# Response to reviewers, Manuscript WES-2024-164

## Reviewer 1:

Figure 1: A re-rendering of Figure 7 of the original manuscript, using the rotor equivalent wind speed method suggested by the reviewer.

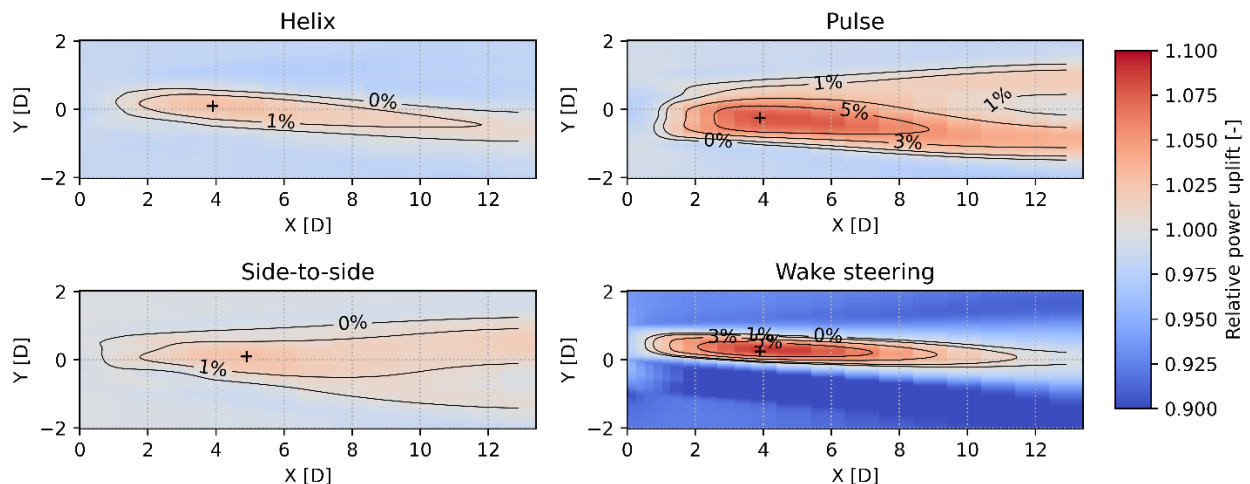
Furthermore, I think the methodology of chapter 3.2.2 can be improved by considering a different method to calculate the power of a virtual turbine, for example by using the rotor equivalent wind speed (Wagner, R., Courtney, M., Gottschall, J., Lindelöw-Marsden, P., 2011. Accounting for the speed shear in wind turbine power performance measurement. *Wind Energy* 14, 993–1004), instead of current equation 3. Furthermore, I believe there are some typos in equations 3 and 4.

The typos have been corrected, and we have investigated the alternative methodology proposed by the reviewer. The method of rotor equivalent wind speed by Wagner et al is mainly designed to account for lidar measurements at different heights, and the difference in rotor swept areas at these heights. In our simulations, we have access to wind speed data over a relatively fine, evenly distributed grid around the rotor swept area. Using the average of all these grid points is effectively equivalent to averaging at different heights and subsequently multiplying by the rotor swept area at each height. Nonetheless, we have implemented this methodology and used it to regenerate Figure 7. The result is shown below. When this Figure is compared to the original found in the manuscript, the differences are shown to be small to the point of being impossible to perceive. We believe this confirms our original results, and therefore justifies sticking to the original methodology described in the manuscript.
